MEMORANDUM

Date:	April 15, 2026	GTS: 240903
From:	GTS	
To:	City of Beaumont	
Cc:	Chambers Group	
Subject:	Sight Distance and Swept Path Analysis – Beaumont City Yard Project

This Memorandum contains a review of the following items in the site design for the site's four entrance/exit driveways:

Exhibit 2.4

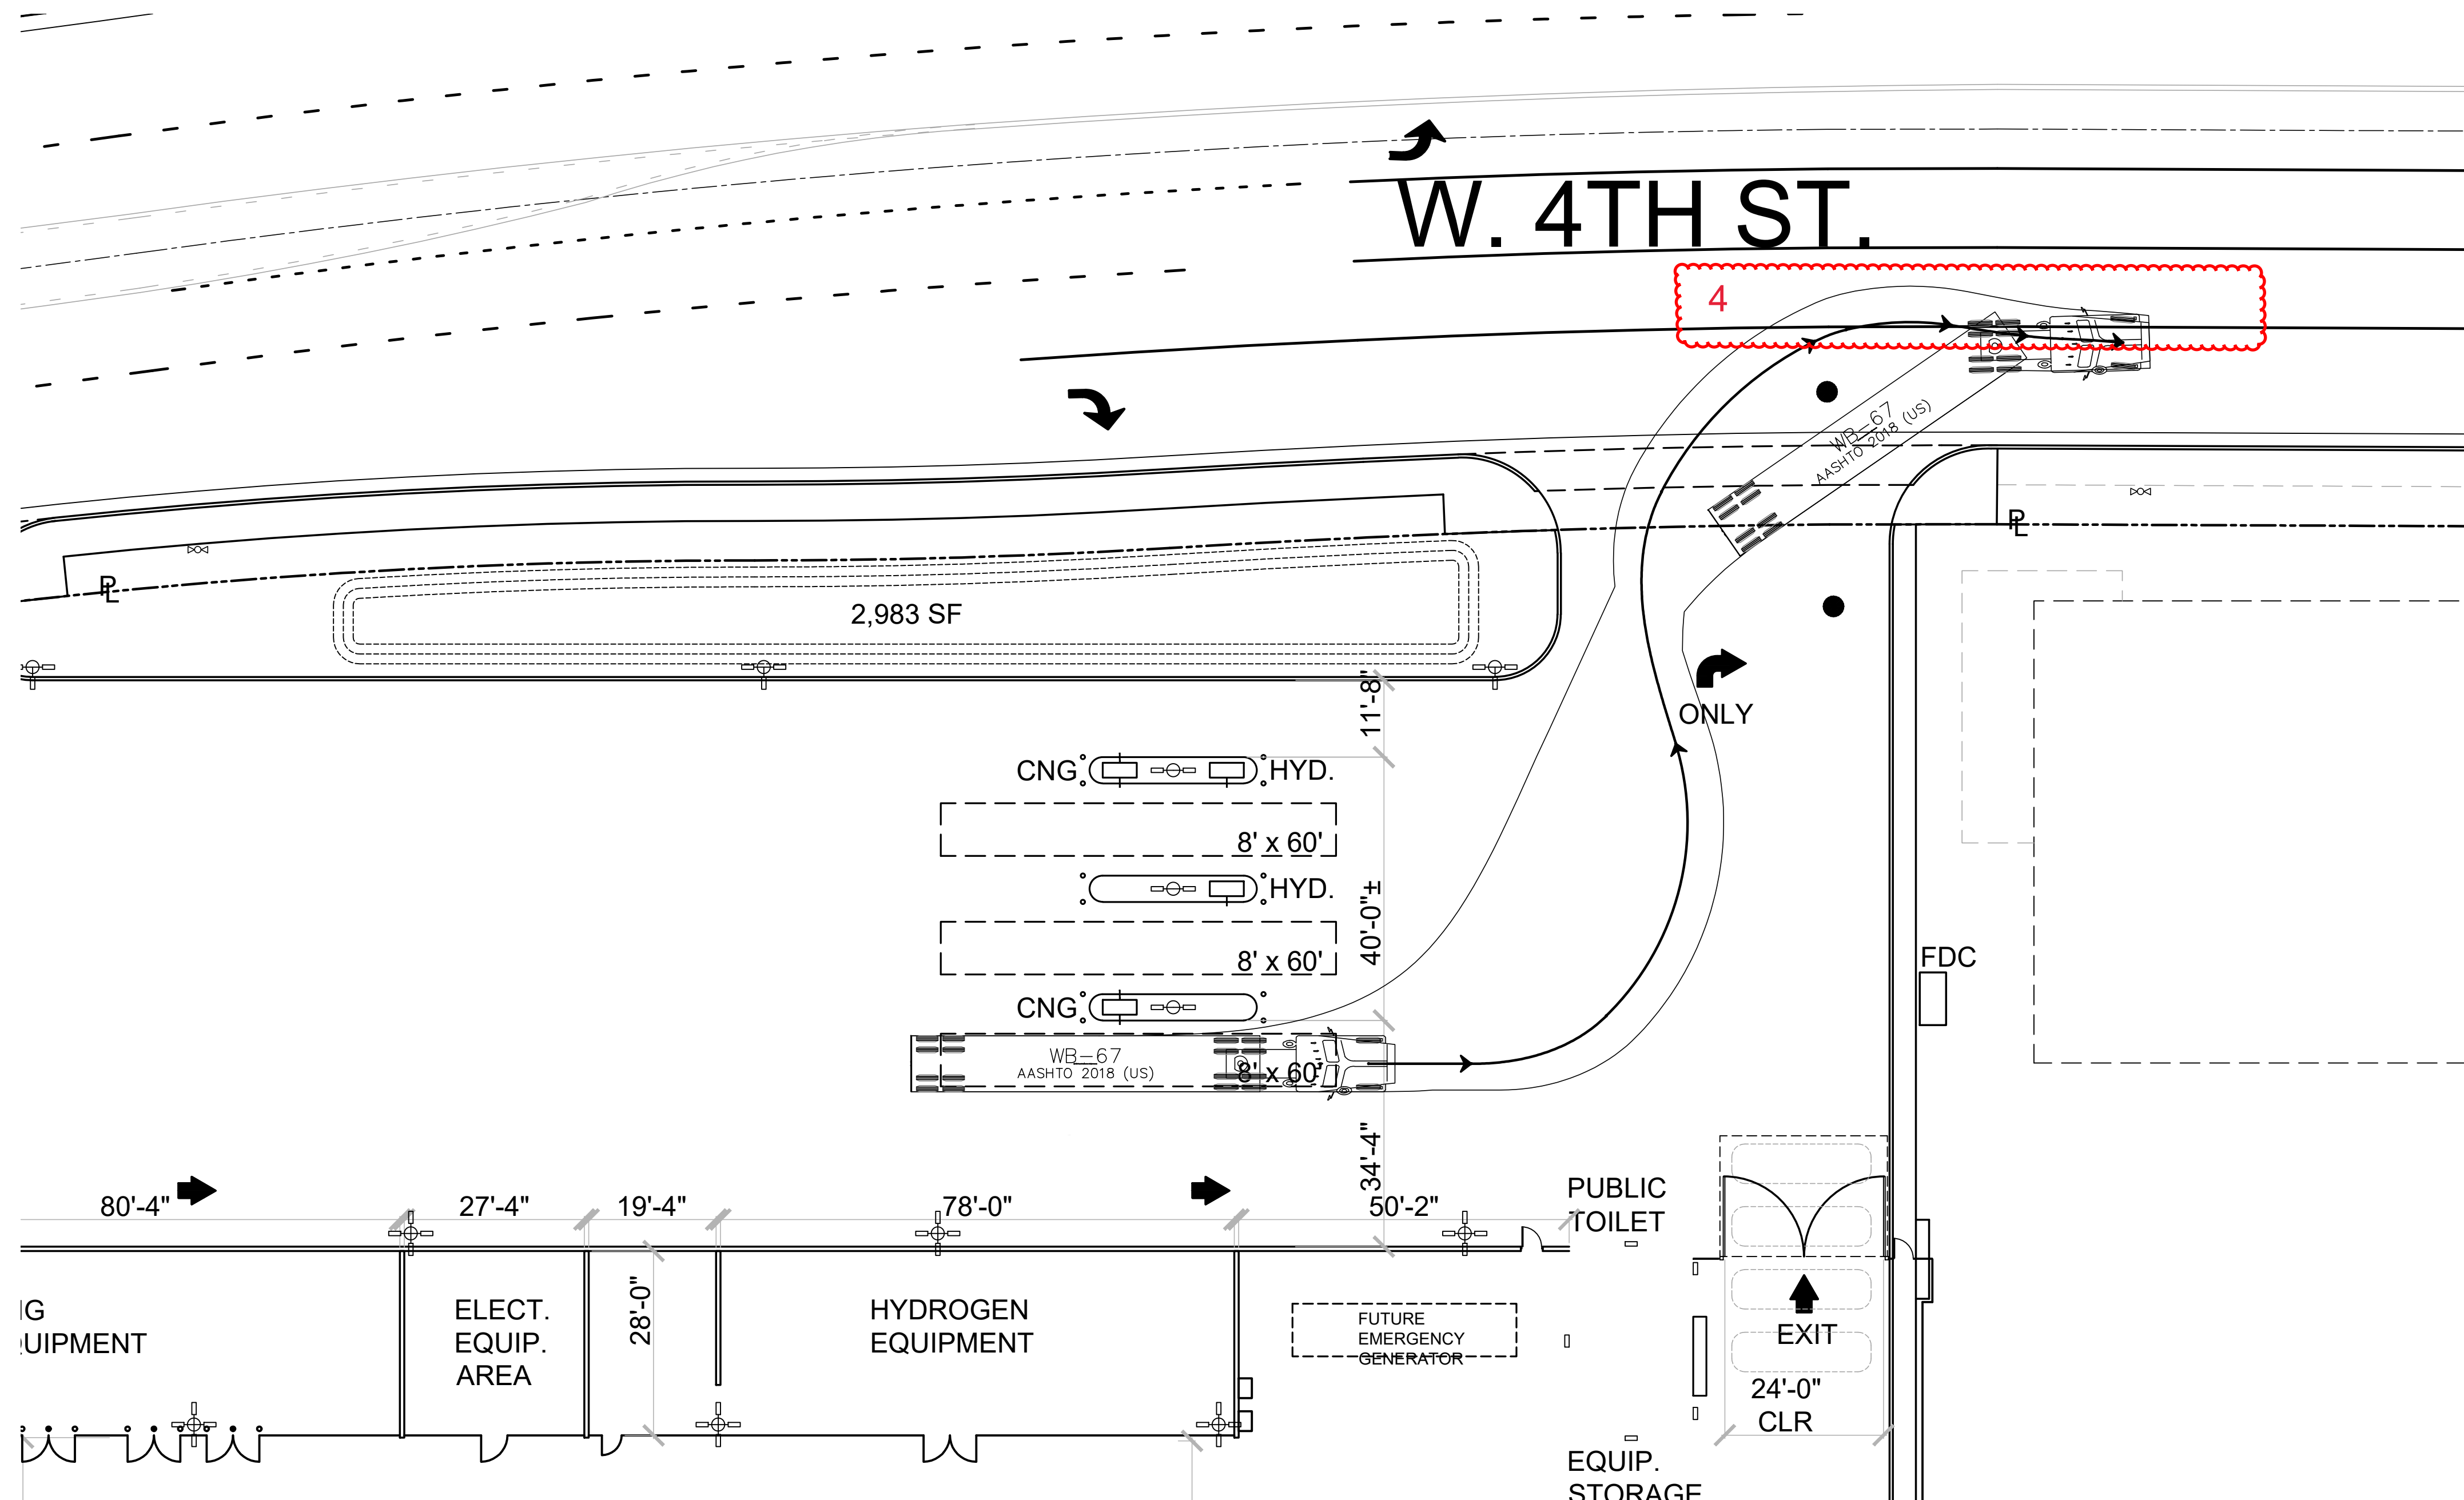
4. At the north driveway, if buses need to exit and use the through lane to proceed eastbound on W 4th Ave, some modifications to the striping and pavement markings may be required. Currently there is a solid white line that would be crossed by vehicles making this movement, and a truck prohibition pavement marking in the eastbound through lane on W 4th Ave approaching Veile Ave (see Exhibit 2.4; photo shown in Exhibit 2.1).

Exhibit 2.5

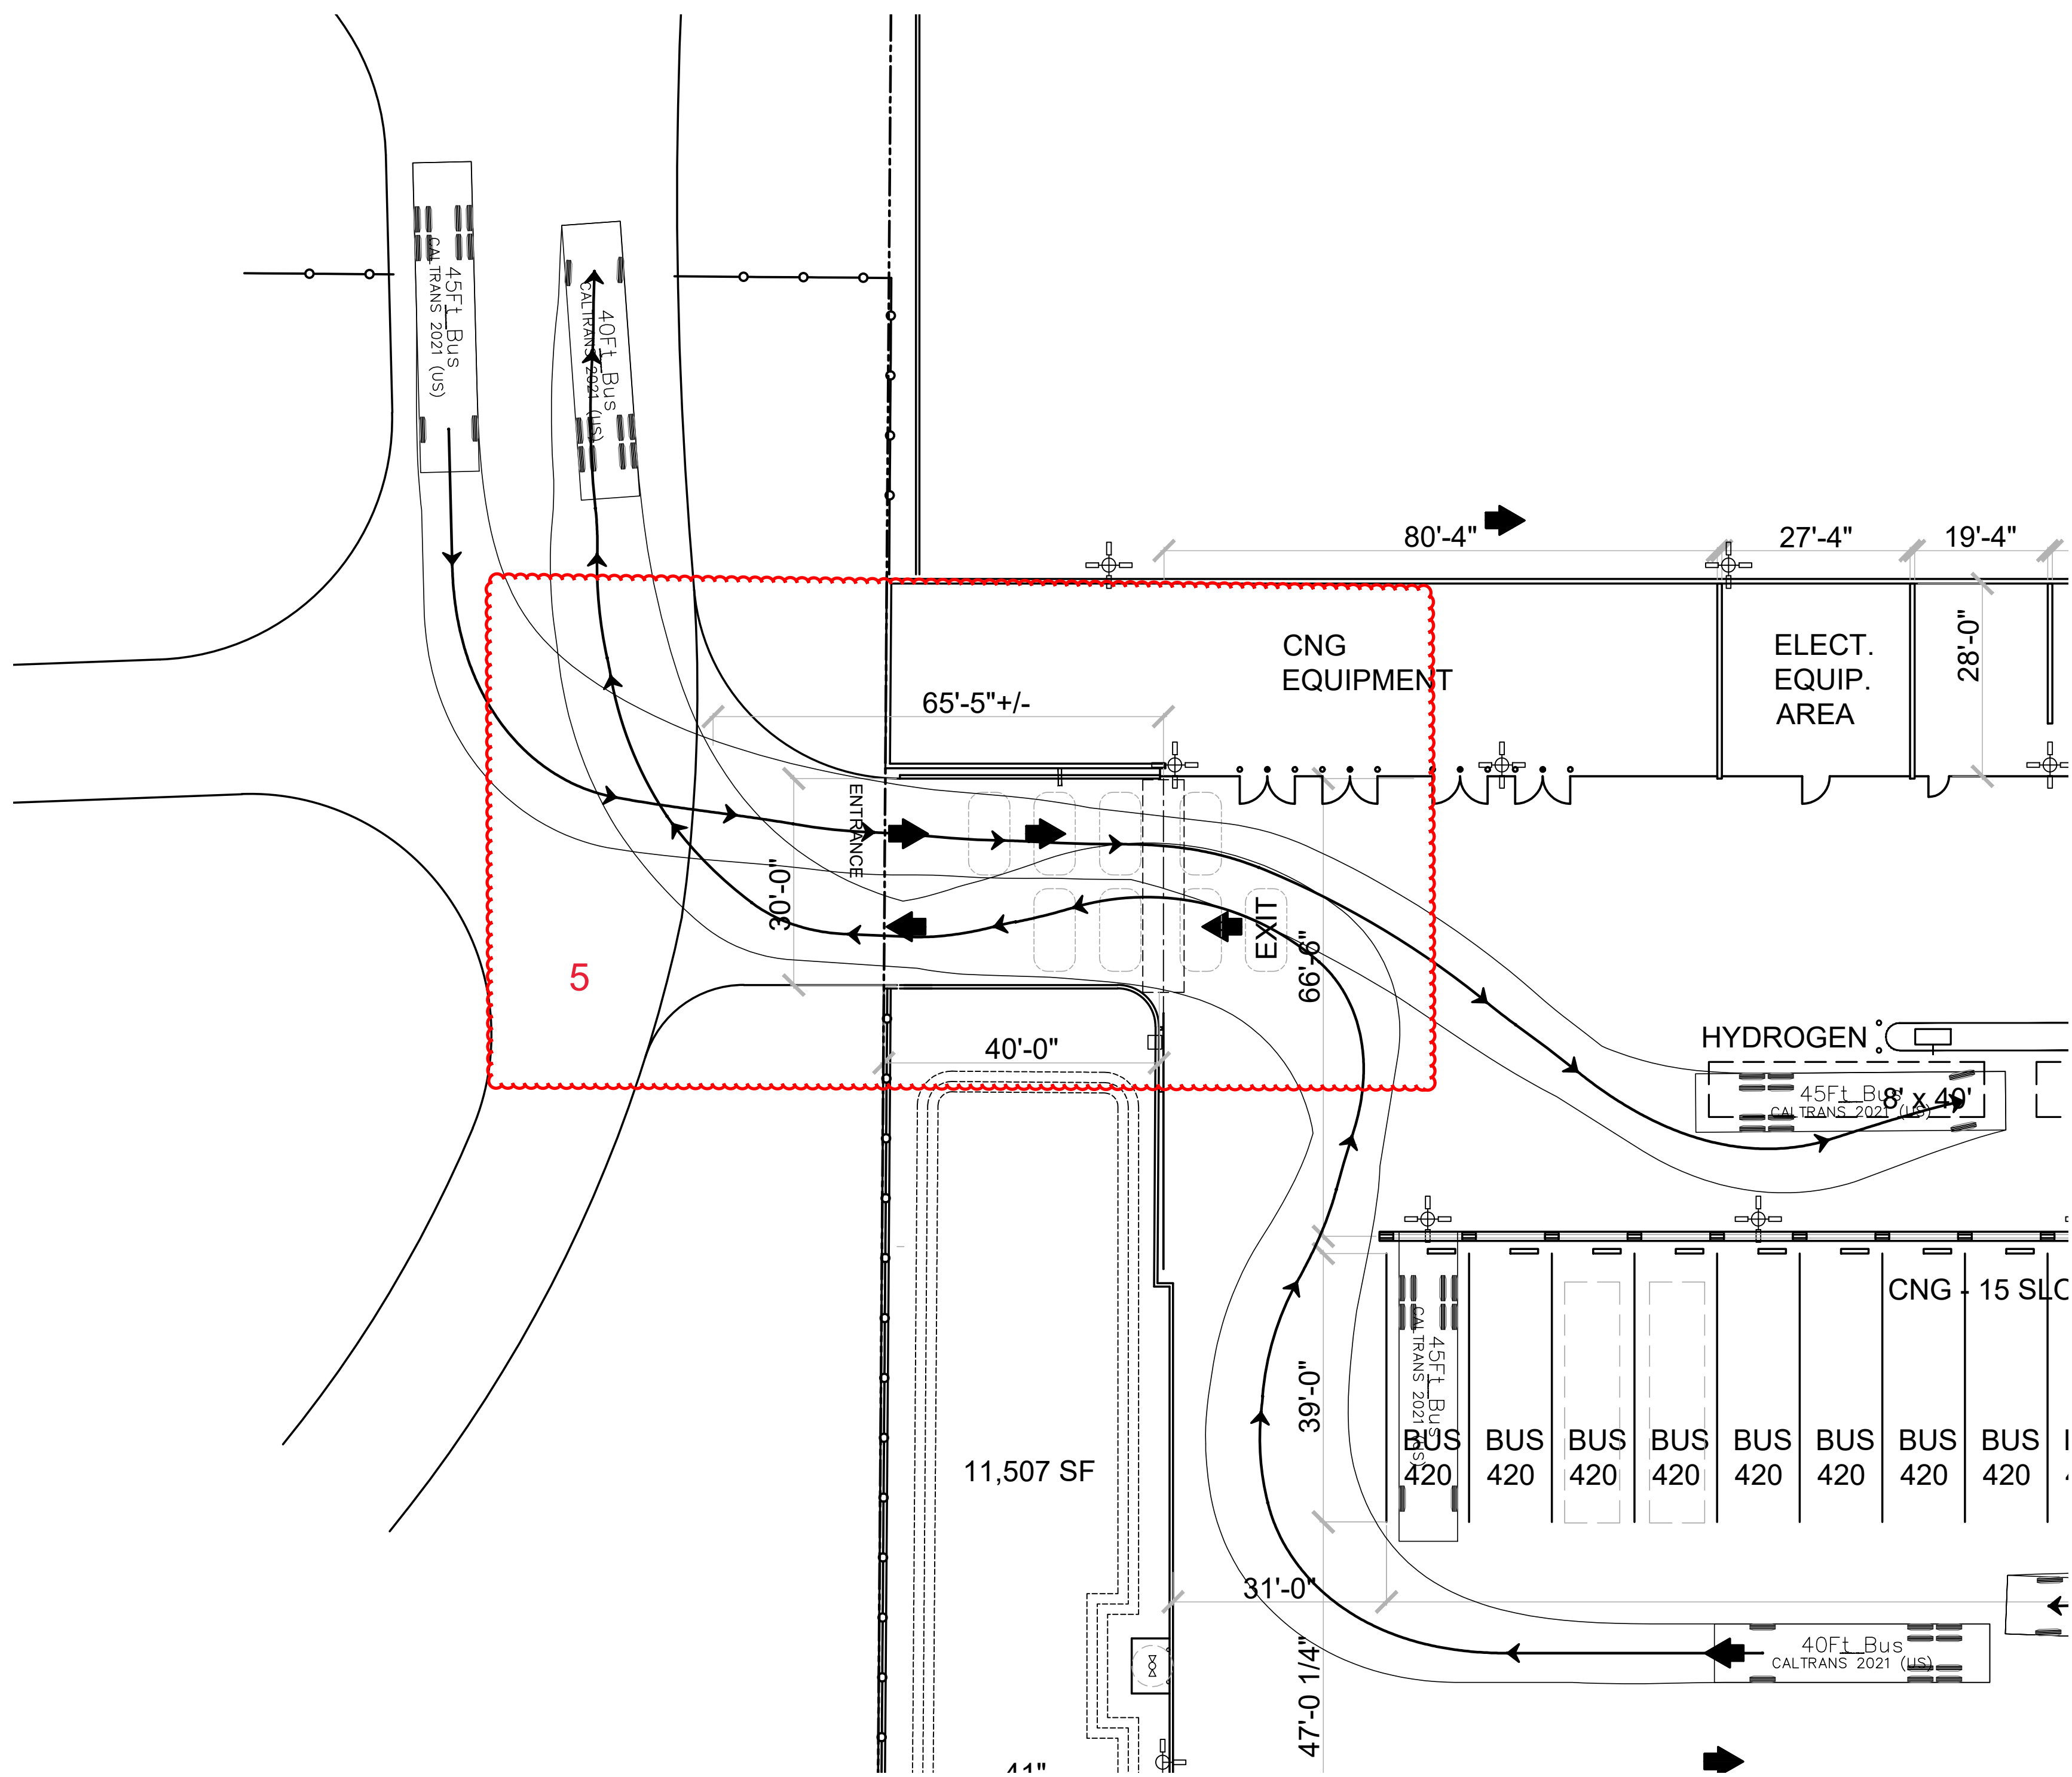
5. At the entrance/exit on the west side of the site, two vehicles entering and exiting at the same time could conflict with one another (see Exhibit 2.5).

Exhibit 2.6

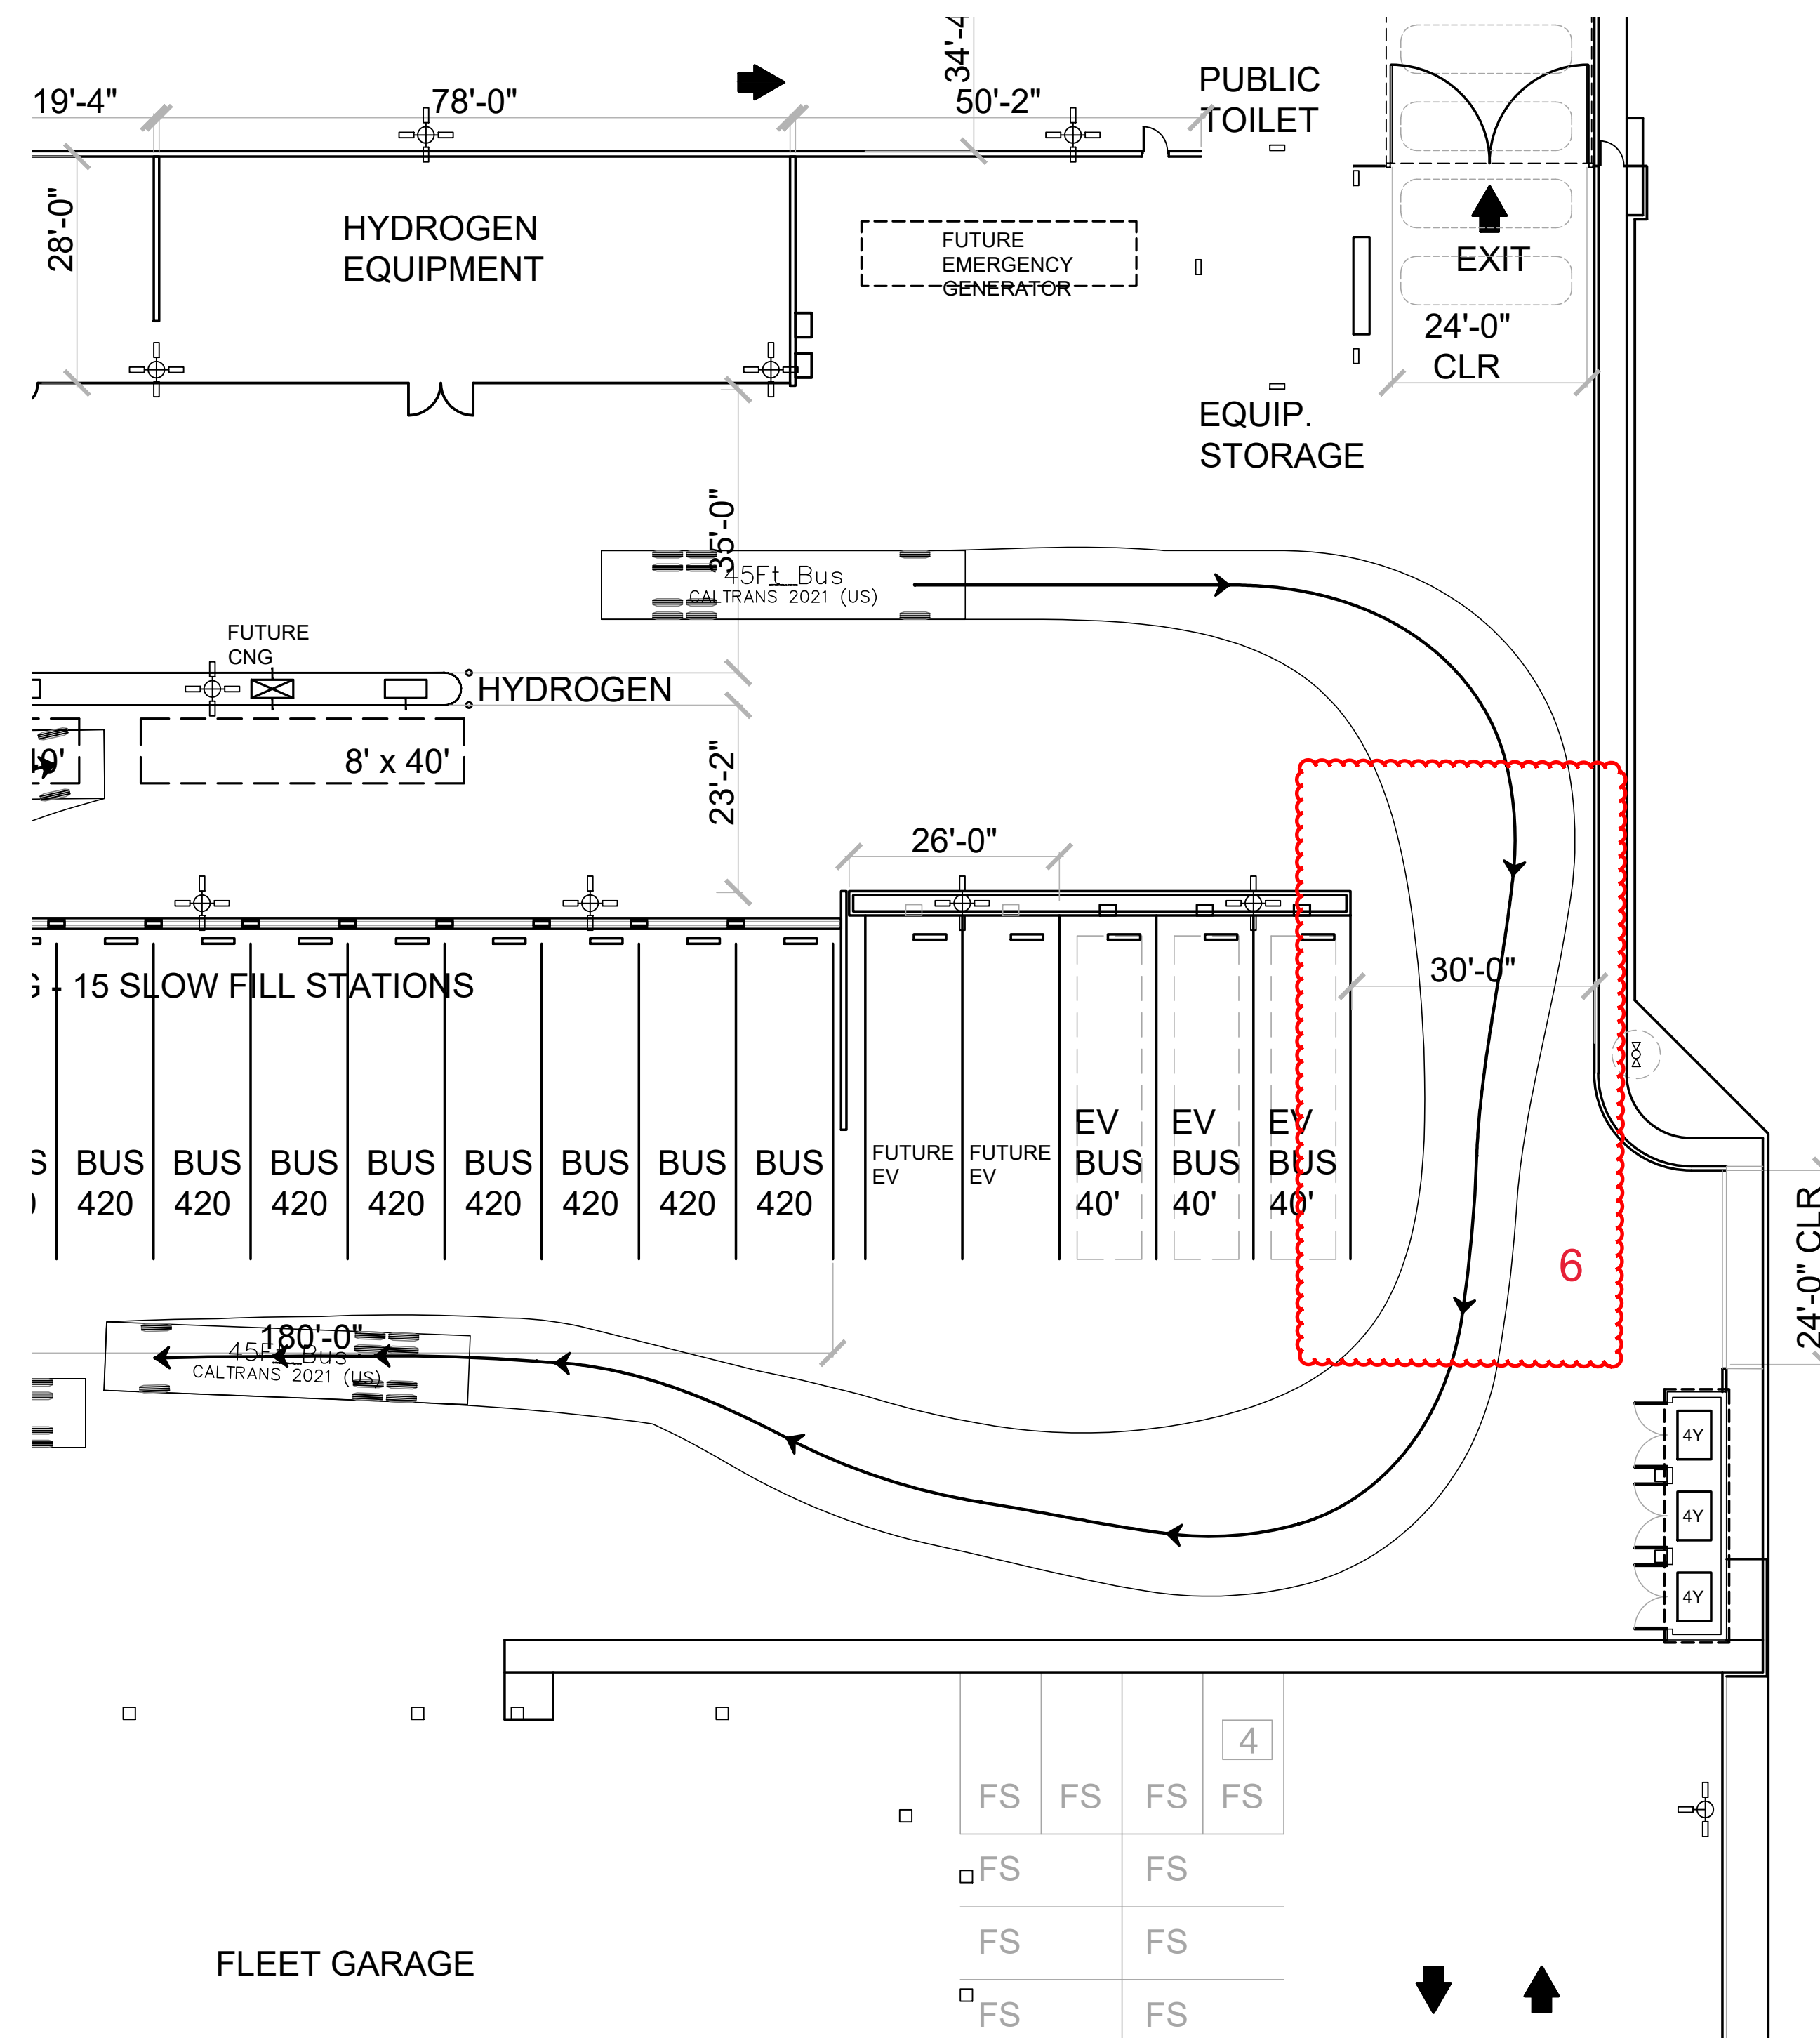
6. Near the center of the site, a vehicle driving around the corner near the EV charging spaces as shown in the exhibit could conflict with another vehicle going in the opposite direction. As shown, the swept path of a large vehicle going in one direction takes up most of the available space (see Exhibit 2.6).
